**Subject: EIS Advice - Beauchamp Road, Hillsdale, Affordable Housing (SSD-83256478)
(Bayside)**

CPHR response to EIS Advice - Beauchamp Road, Hillsdale, Affordable Housing (SSD-83256478) (Bayside)

Figure 5.4: PMF Design Storm Flood Hazard

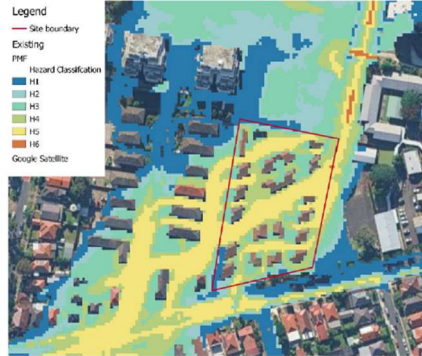
<i>Extent and Timing</i>	Pre-determination
2.	<i>The proposal includes intensification of development in a floodway and poses increased risk to life</i>	<p>The subject site includes an area which acts as a floodway in the 1% AEP event (see below). The entire site becomes a high hazard floodway in the PMF event. The proposed management of the floodway by concentrating flows to a designated floodway between the two buildings has increased the risk on site.</p> <p>Risk is a combination of hazard and exposure. The proposal increases hazard on site due to the proposed concentration of the onsite floodway and significantly increases risk due to the increased numbers of residents who will be exposed to the hazard.</p>

The proposed intensification of development on this site should be reconsidered unless it can be redesigned to manage risk to life.

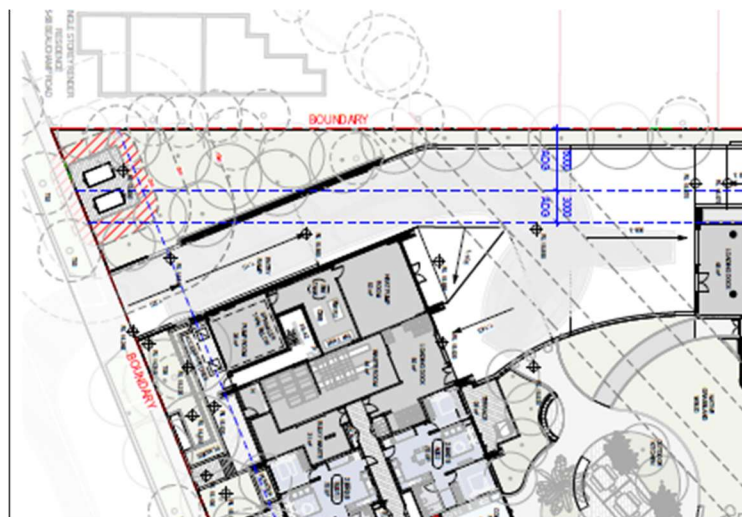
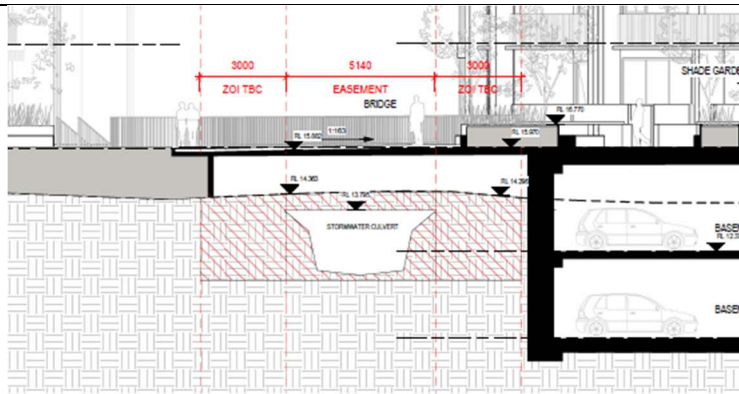
3. *The design of the development includes a large bridge over the flow path which is not consistent with Sydney Water's advice*

Car access to the rear building and the proposed basement is proposed to be across a bridge built over the easement. The bridge is not described in the FIRA and is only evident in the architectural plans (see below). It is not known if the bridge has been modelled in accordance with the details shown on the architectural plans.

The extent of the bridge appears to be inconsistent with the advice from Sydney Water and will have implications on the ability for Sydney Water to access and maintain the stormwater easement.

The bridge is shown as impacted by flooding in the 1% AEP event and is H5 hazard in a PMF event. The bridge poses a significant risk if used by residents during a flood event.

The pedestrian bridge over the easement is not described in the FIRA and the flood immunity of this access is not able to be determined from the supplied information.

- Confirmation from Sydney Water is required to verify whether the bridge location and design area acceptable.
- Confirmation is required on how the bridge was incorporated in the flood modelling including the approach used to model potential blockage of the bridge opening.
- Reconsider the bridge levels to reduce the risk of inundation. Additional safety measures are required to ensure cars are not washed off the bridge during a flood event.
- Provide pedestrian access above the PMF level to the rear building.
